NOTE 48
ASI2816 Module Revisions

The ASI2816 streaming radio tuner is configured with up to 4 tuner modules. There are various revisions of the modules available:

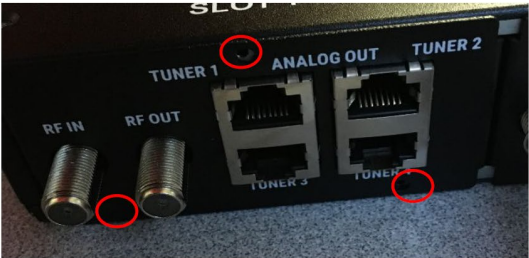
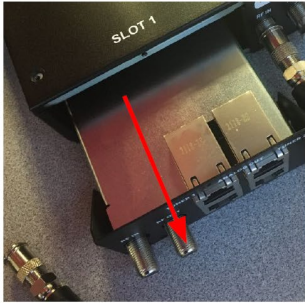
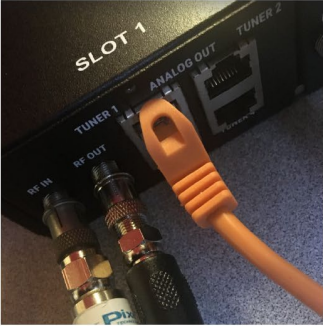
Revision B & C: Use four stereo USB audio recording interfaces
Revision D & E: Use one 8 channel USB audio recording interface

1. Revision B & C cannot be mixed with revision D & E, i.e.an ASI2816 chassis needs to be populated with either all revision B & C or all revision D & E.
2. A maximum of two revision B & C modules can be used in one ASI2816 chassis. Any more will cause noise in the audio streams
3. Three or more modules in an ASI2816 chassis require revision D or E modules. If you have purchased an ASI2816 with three or more revision B or C modules then we will replace those modules with revision D or E at no charge - please contact AudioScience technical support.
4. Use of revision D or E modules requires firmware version 0.7.1 or higher.
